Year 2 Monitoring Report

CATBIRD SITE

NCDMS Project #100022 (Contract #7186)
USACE Action ID: SAW-2017-01506
DWR Project #20171039

RE: Catbird Site: Year 2 Monitoring Report (NCDMS ID 100022)

Figure 2

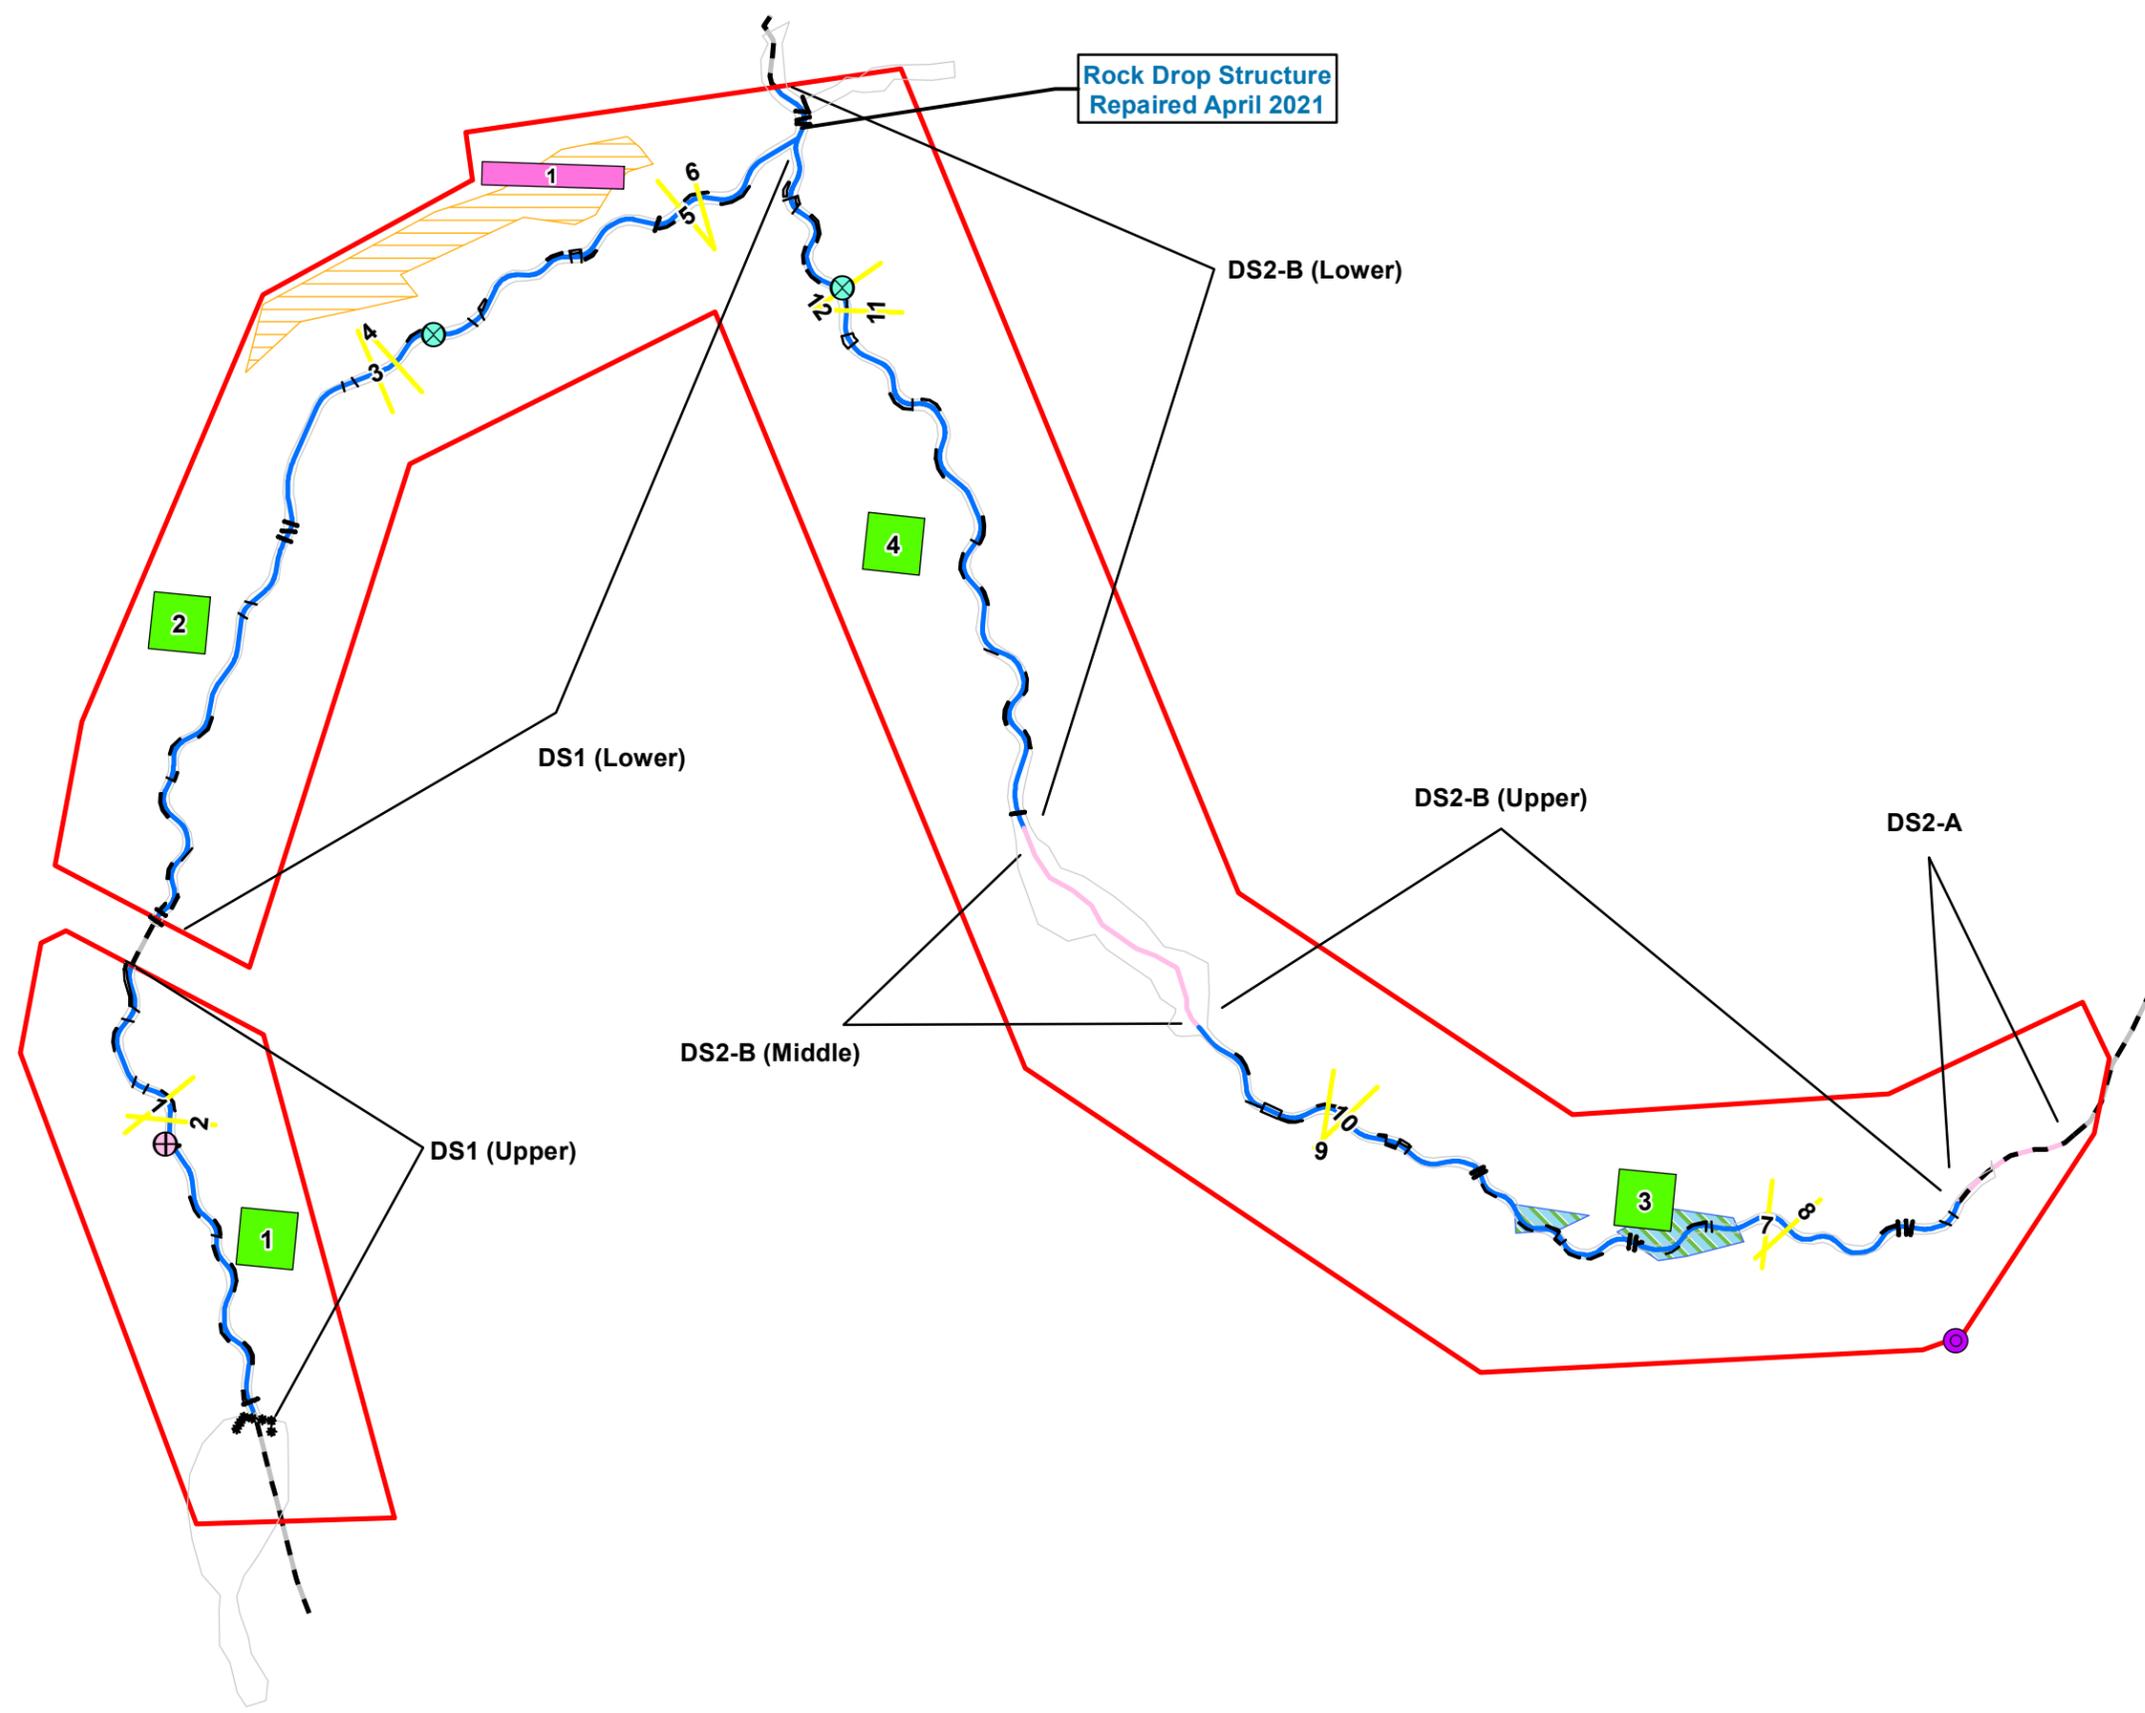
During the October 2021 field visit by DMS staff, several minor areas of concern were noted including two areas of floodplain scarring / slope rilling, and a cluster of invasives present in the E2 section. Please document all areas of concern thoroughly and map accordingly.

If available please provide a close up dated photo of the rock drop structure repaired in April 2021. The photo provided shows more of the upstream riffle than the repaired structure.

[These areas have been noted and will be investigated and, if needed remediated, in MY3.](#)

[We have included a photograph of the repaired structure taken just after repair. More photos will be taken in MY3 for submittal. Photo can be found in support files>visual assessment data.](#)
